Planning Commission Staff Report

October 26, 2016
Item 5.b.

- SUBJECT:** Vesting Tentative Map 8352
- APPLICANT/
OWNER:** GHC Lund Ranch, LLC
- PURPOSE:** Application for a Vesting Tentative Tract Map to subdivide an approximately 194.7-acre property into 46 lots for 43 single-family homes (approved under PUD-25) and three lots to be dedicated to the City of Pleasanton for permanent open space.

Figure 1: Proposed Vesting Tentative Map (Tract 8352)

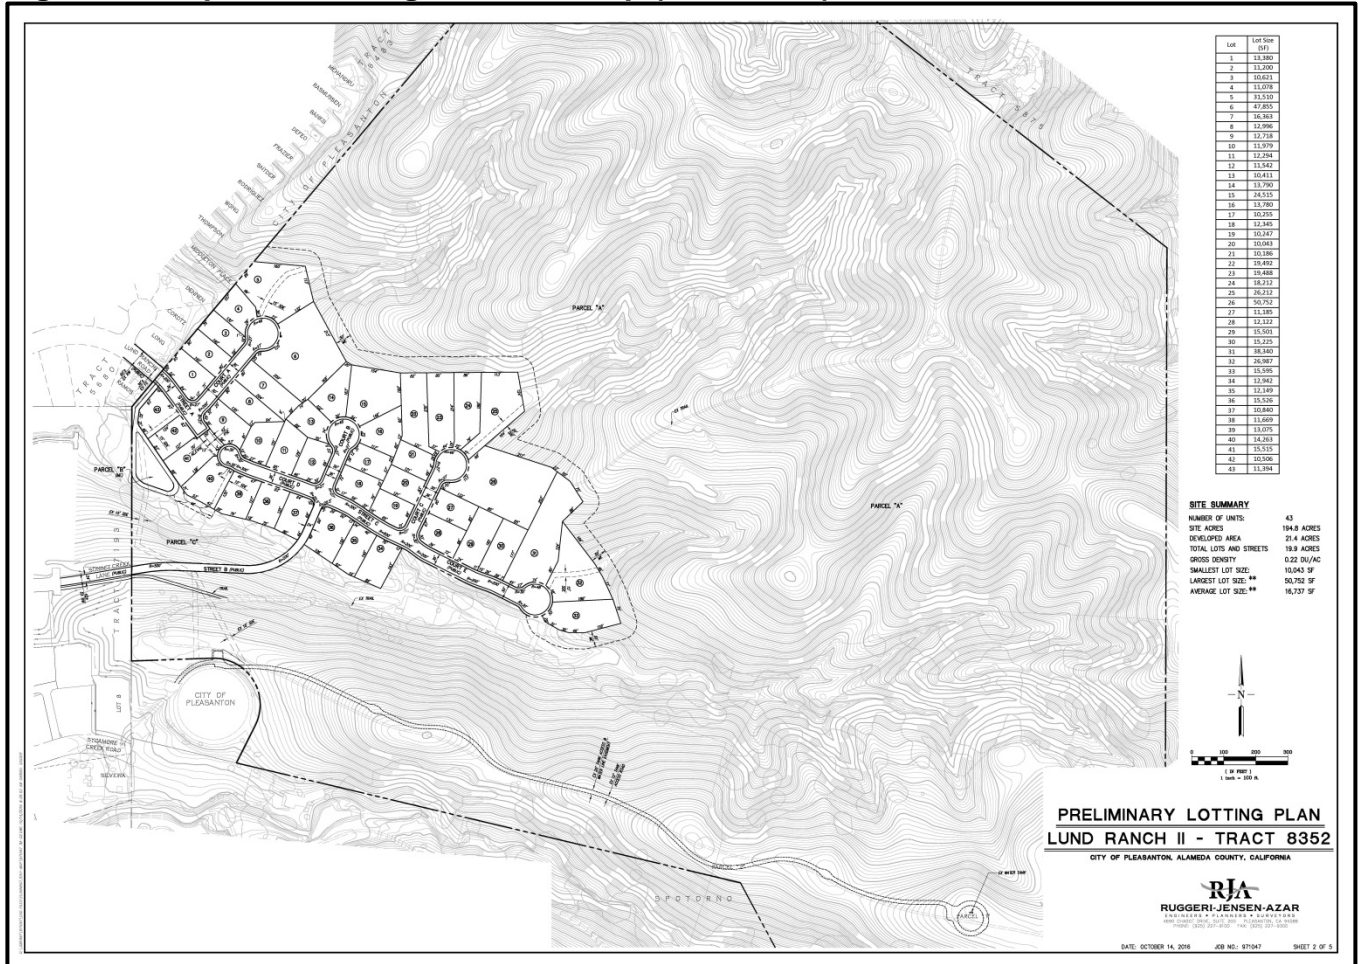
The details of the requested VTM (Figure 1) are summarized below:

The proposed VTM is substantially the same as the PUD development plan (PUD-25) approved by the City Council and endorsed and ratified by a majority of the voters. As is typical for a project of this size and complexity, a few minor revisions have been shown on the tentative map as noted below:

Figure 2: Proposed Pad Elevation Changes for Lots Visible from Lund Ranch Road

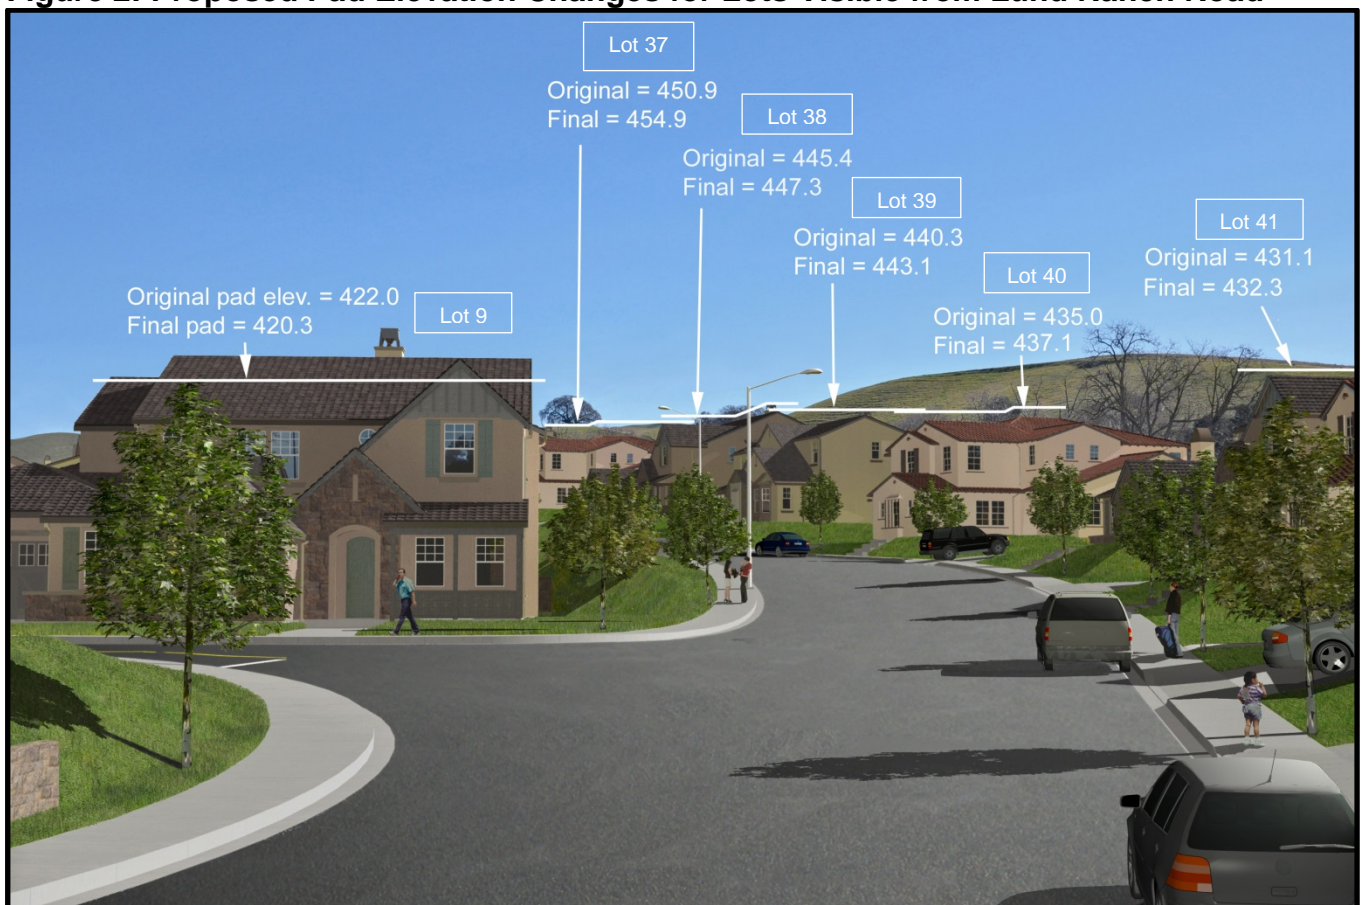
- The finished pad elevations for some of the lots would decrease or increase approximately one foot to five feet in height. The most visually noticeable changes will occur primarily within the central to eastern portions of the project and not on the lots abutting the adjacent residential neighborhoods to the west. These changes are a result of the elimination of seven lots proposed along "Court E" during the PUD review process. The elimination of these lots caused the cut and fill earthwork initially proposed for the project to become out of balance by approximately 30,000 cubic yards. Thus, without the proposed grading changes, the excess soil would have to be off-hauled with trucks through the adjacent residential neighborhoods to the west. The proposed grading changes allow for the excess soil/cut material created by the project to be redistributed on-site rather than being off-hauled.

Generally speaking, on hillside developments, smaller trucks are used for off-hauling and can carry approximately nine cubic yards of off-haul material per trip (standard trucks can carry 16 to 18 cubic yards of off-haul material per trip); therefore, the proposed grading changes would eliminate approximately 3,333 off-haul truck trips through the adjacent residential neighborhoods to the west. Figure 2 is the visual simulation prepared for the PUD plan from a viewpoint at the terminus of Lund Ranch Road; the white lines depict changes in building elevations resulting from the currently-proposed change in pad elevations. Staff notes that while not shown in Figure 2, the pad elevations for the lots along the western property line of the project site (primarily Lots 1 through 5, and 43) would increase approximately two and one-half inches to one-foot and that would have minimal visual impact as it is within a typical height deviation created when project plans and calculations are refined between the PUD plan and the final grading plan.

Figure 3: PUD Approved versus VTM Proposed Street B Alignment

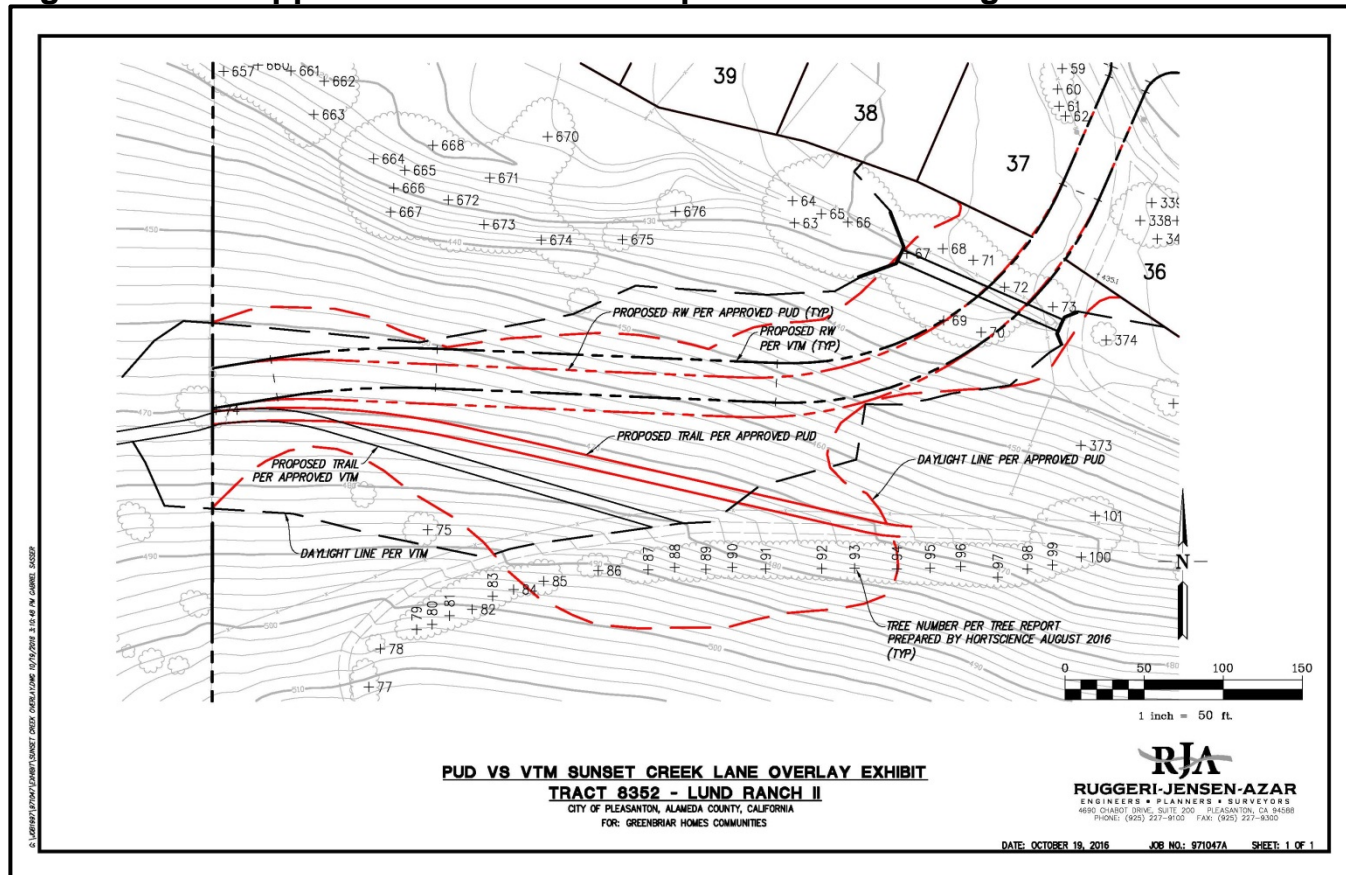
2. The alignment of Street B, which connects Sunset Creek Lane to the project, has been modified pursuant to the PUD conditions of approval to reduce a number of impacts associated with the previous PUD, including the amount of grading within areas with a slope greater than 25%, the amount of cut and fill associated with the road improvements, and the number of Heritage Trees to be removed. Figure 3 provides a comparison of: (1) the PUD approved road alignment and the VTM proposed road alignment; (2) the PUD approved trail (pedestrian connection) alignment and the VTM proposed trail (pedestrian connection) alignment; and (3) trees removed under the PUD and VTM. Under the VTM, seven Heritage Trees (Nos. 67 through 73) would be removed adjacent to the culvert under Street B and

10 olive trees (Nos. 85 through 94), five of which are Heritage Trees, that were approved for removal under the PUD, would now be preserved. The Heritage olive trees that would be preserved under the VTM are a prominent visual feature of the north-facing hillside, and are visible from the Lund Ranch project site and Bonde Ranch Open Space to the north. In addition, the VTM would result in the removal of a non-Heritage olive tree (No. 75) not approved for removal under the PUD. Staff notes that no other tree removals have been altered in the rest of the site as part of the VTM. Table 1 provides a comparison of the Sunset Creek Lane extension impacts approved with the PUD Development Plan and the changes/improvements made with the proposed VTM.
